Amendments to Part E of the “Rules for the Classification of Ships”

Effective from 1/4/2026

List of the amendments:

Part E – Service Notations Chapter/Section/Paragraph amended	Reason
Ch 7, Sec 2, [7.1.1] and [7.3.2] Ch 8, Sec 3, [6.4.1]	<p>to limit the application of:</p> <ul style="list-style-type: none"> • paragraph 2.2 of IACS UR F44 (Rev.3) “Fore peak ballast tanks and space arrangements on oil & chemical tankers” relevant to spaces or voids defined as non-hazardous spaces having access to other non-hazardous spaces (such as bosun store); and • IACS UI SC211 (Rev.1) "Protection of fuel oil tanks and designation of fore peak spaces" UI SC211 (Rev.1) <p>to ships flying flags of Administrations having no objections on UI SC211 (Rev.1) and IACS UR F44 (Rev.3), paragraph 2.2. These amendments – due to Liberia’s prohibition on applying UI SC211 (Rev.1) – were notified to IACS by submitting a reservation on IACS UR F44 (Rev.3), paragraph 2.2.</p>

Figure 5 : Sample 1 (1/1/2026)

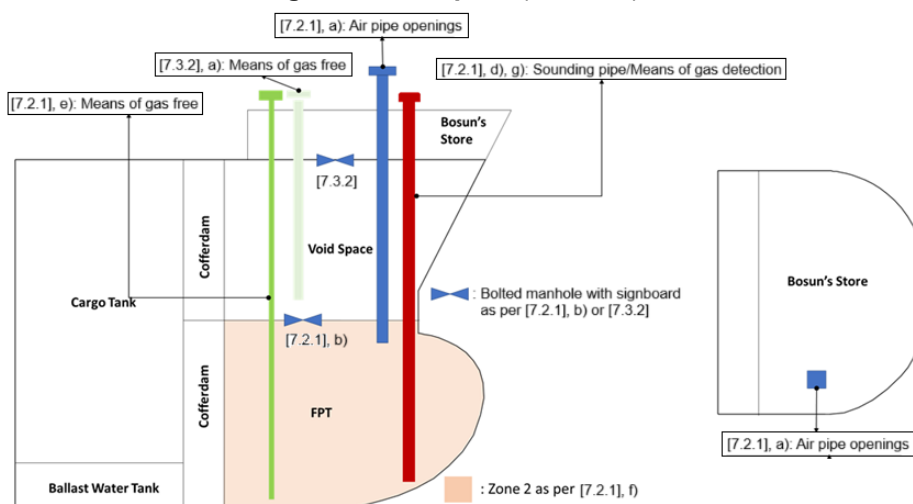
In case any spaces or voids are defined as non-hazardous spaces and have access to other non-hazardous spaces (such as bosun store), the following applies unless instructed otherwise by the Flag Administration:

- For any non-hazardous space with access to a hazardous space (example: fore peak ballast tank), the non-hazardous space is to have access directly to open deck and is to be gas freed directly from open deck, and not through the non-hazardous space (example: bosun store).
- Access from bosun store to a non-hazardous space (example: void) having access to hazardous space (example: fore peak ballast tank) may be accepted through a gas tight bolted manhole, with signboard stating that the non-hazardous space cannot be entered until the space is confirmed gas free. Separation of such spaces are described in IEC 60092-502:1999 section 4.1.4 and 4.1.5 as applicable.
